Access Compliance Report

Public Rights-of-Way

(Curb Ramps)

Intersection ID: 50598	Main Street: BENDING_BRANCH_RD	Cross Street: BEAR_GRASS_LN	Location: S
ADA ID: 98873E6950CB	Ramp Type: Perp	Initial Pass/Fail: Pass	Overall Compliance: No
			Severity Score: 5

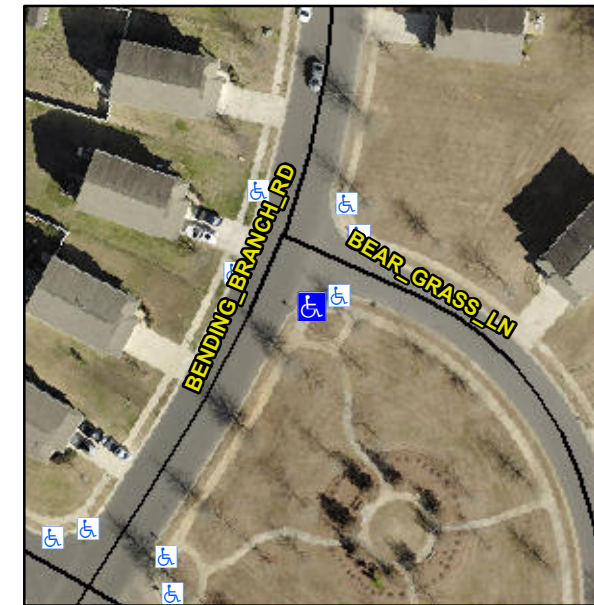
**Not Found, R304.2.2-Perp, R304.3.2-
Para, R304.5.4**

**Remove & Replace Entire Ramp.
Remove & Replace Gutter.**
